Summary of Public Review Comments and Responses:  
*Draft Inventory of U.S. Greenhouse Gas Emissions and Sinks: 1990-2018*

May 2020  
U.S. Environmental Protection Agency  
Office of Atmospheric Programs  
Washington, D.C.

Responses to Comments Received during the Public Review Period on  
the *Inventory of U.S. Greenhouse Gas Emissions and Sinks: 1990-2018*

APPENDIX

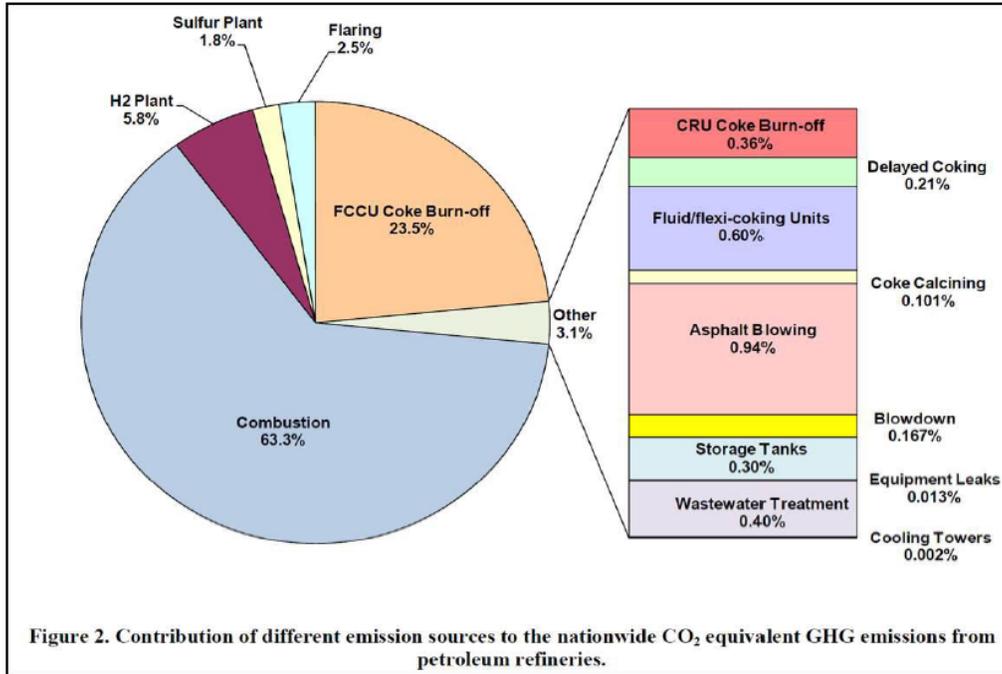
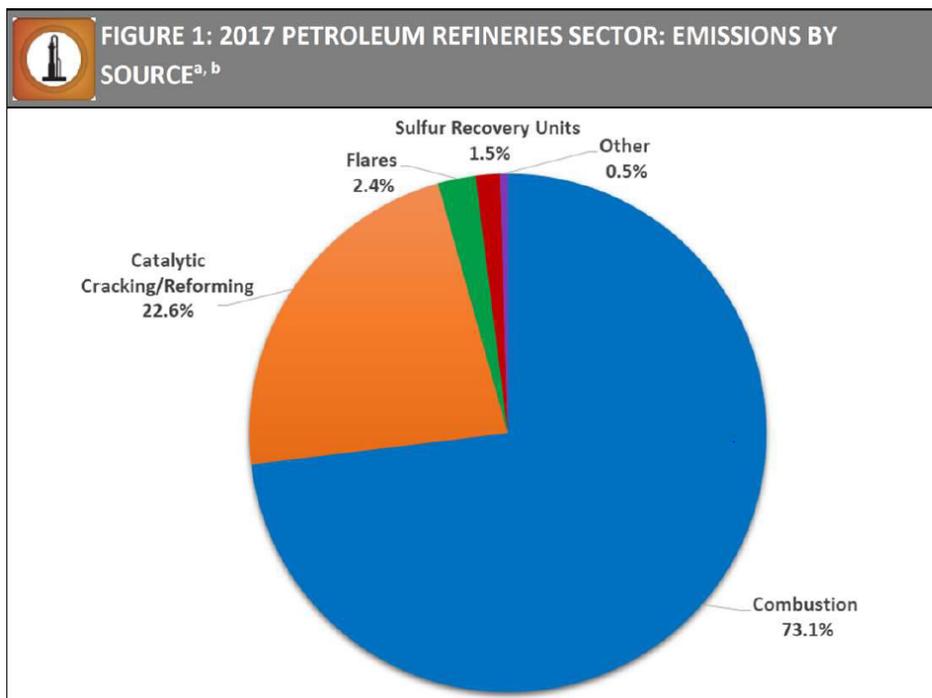
In both the 2015<sup>2</sup> and 2019<sup>3</sup> Industrial Profile reports, EPA includes charts that summarize petroleum refinery sector GHG emissions by source (see Appendix below). The refinery GHG emissions by source include: Combustion of Fuel, (percentage share of 63 and 73 respectively), Catalytic Cracking/Reforming (approx. 23%), Flaring (approx. 2.5%), and other sources (such as Hydrogen Plant, Sulfur Removal Plant, etc.). The sum of the published 2015 and 2019 percentage shares of Combustion of Fuel, Catalytic Cracking/Reforming, and sources other than flaring total more than 97 percent.

As written, the 2020 report implies that the numbers are now transposed and that flaring now accounts for 98 percent of a refinery’s GHG emissions. The calculations in the 2015 and 2019 reports are also more consistent with the refining industry’s own determinations on the contribution of flaring to the overall GHG emissions in a refinery.

AFPM recommends that EPA reevaluate the refinery GHG summary and apply from the earlier reports the determination that flaring contributes a very small portion (less than 2.5%) to a refinery’s overall GHG emissions.

**Response:** *The Inventory text in Section 3.6 on Petroleum Systems has been edited to clarify that the emissions discussed in this section are fugitives (leaks, venting, and flaring), not combustion sources. See pp. 3-68 to 3-70 in Section 3.6 of the report.*

8 **Figure ES-17: 2018 Key Categories (MMT CO<sub>2</sub> Eq.)<sup>a</sup>**

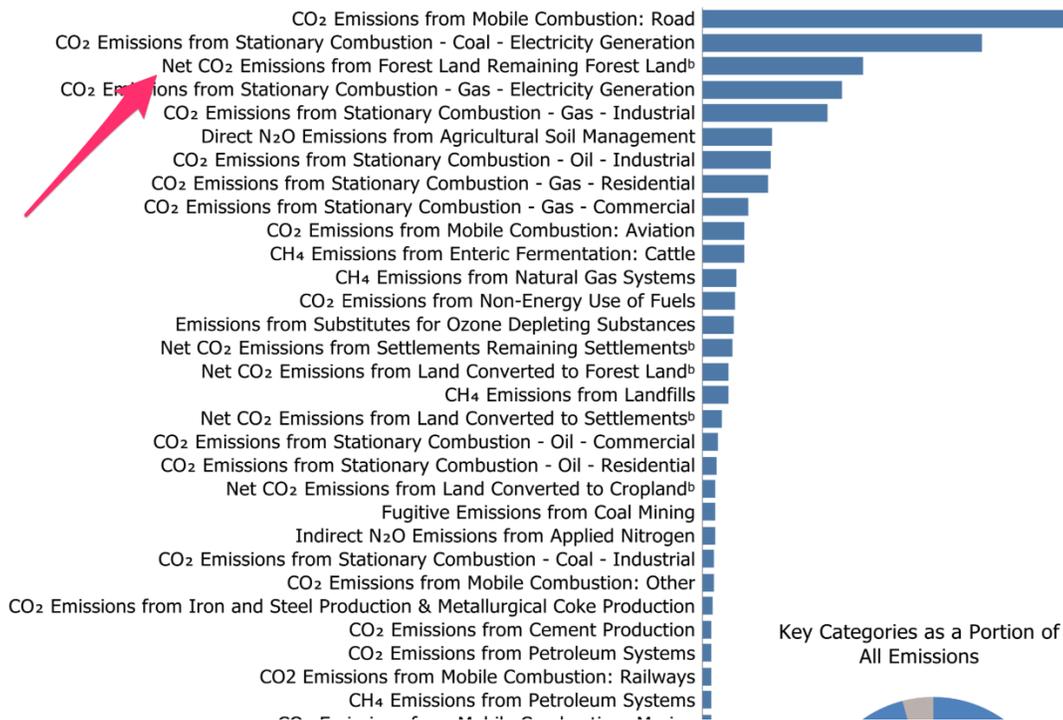
**Comment 30: Re: Figures ES-17 on page ES-30 of the Executive Summary**

This figure attempts to provide an overview of the key categories of emissions, but combines categories that have net positive and net negative carbon emissions in one chart.

When I was looking at the chart, I didn't initially see that categories like "Net CO<sub>2</sub> Emissions from Forest Land Remaining Forest Land" represented a negative impact on carbon emissions, since they were displayed in a similar way to categories with positive impact.

I'd propose displaying those categories in some other way, perhaps by making the bar in the chart a different color -- maybe green instead of blue.

**Response:** Figure ES-17 has been updated to differentiate key categories from the LULUCF sector that have a net negative emissions. See p. ES-29 of the report.
